THOMASVILLE ROAD (HERMITAGE BOULEVARD TO LIVE OAK PLANTATION ROAD) ROADWAY SAFETY AUDIT

SR 61 / Thomasville Road Road Safety Study

Hermitage Blvd./Sandhurst Dr. to Live Oak Plantation Rd.

Sponsored by FDOT District Three Safety Office May 15, 2018

Thomasville Road at School of Arts and Sciences

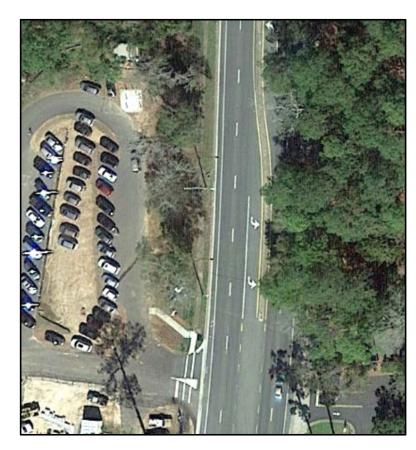
- > Issue
 - Left-turn traffic from school driveway (short- and mid-term)
- > Description of Safety Issue:
 - Left-turns exiting driveway despite NO LEFT TURN sign
- > Suggestion:
 - (Short-term) Install flexible delineator posts around the concrete island to discourage movement
 - Use enforcement to ticket the drivers that are not in compliance
 - (Mid-term) Revise the existing island to be more restrictive for left-turns

Thomasville Road at Oven Park Drive

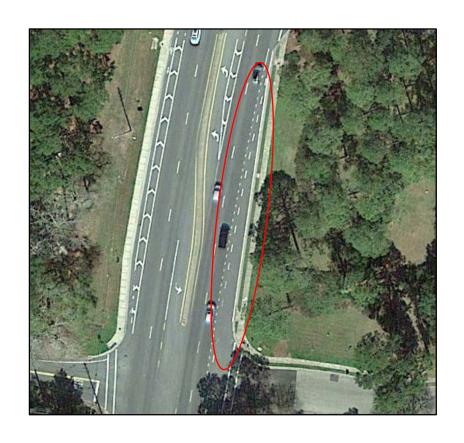
- > Issue
- Location of STOP sign and stop bar (short-term)
- > Description of Safety Issue
 - STOP sign and stop bar for westbound traffic were noted as located too far back to see approaching northbound Thomasville Road traffic
 - Both are properly placed at the back of the curb radius for a side street
 - Motorists are required to stop safely for pedestrians and then move up as necessary to see traffic on the mainline
- > Suggestion
 - No change is required

Thomasville Road at Piedmont Drive

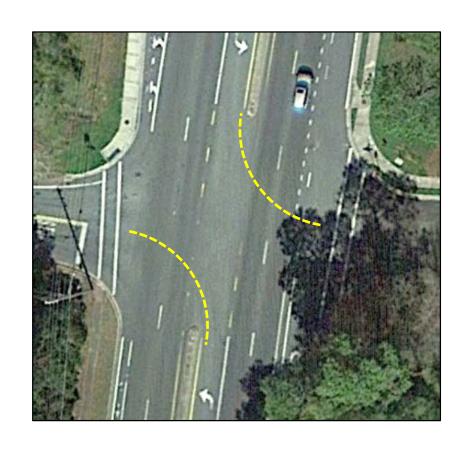
- > Issue
 - Lack of pavement marking guidelines (short-term)
- > Description of Safety Issue:
 - Northbound and southbound left turns lacking pavement guidelines
- > Suggestion
 - Consider adding 2'-4' skip 6-inch yellow stripe pavement markings to help guide motorists

Thomasville Road at Live Oak Plantation Road

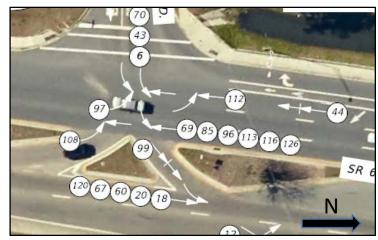
- > Issue
 - Limited sight distance (short-term)
- > Description of Safety Issue
 - Pedestrian rail in the northwest corner obstructs view of southbound approaching traffic.
- > Suggestion
 - Consider replacing the railing with the FDOT design that includes a window for improved visibility

Thomasville Road at Live Oak Plantation Road

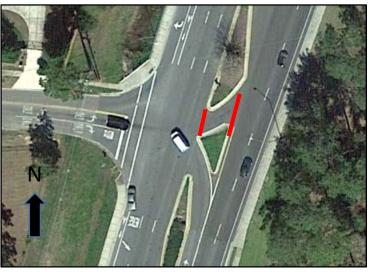
- > Issue
 - Number of crashes involving eastbound left turns (mid-term)
- > Description of Safety Issue
 - 15 angle crashes at this intersection
- > Suggestion
 - Consider eliminating the eastbound leftturn movement at this location.
 - Modify median opening to a directional northbound opening
 - Eastbound left turns required to make a rightturn followed by a U-turn
 - Access management study required along the segment to determine the effects of U-turn traffic
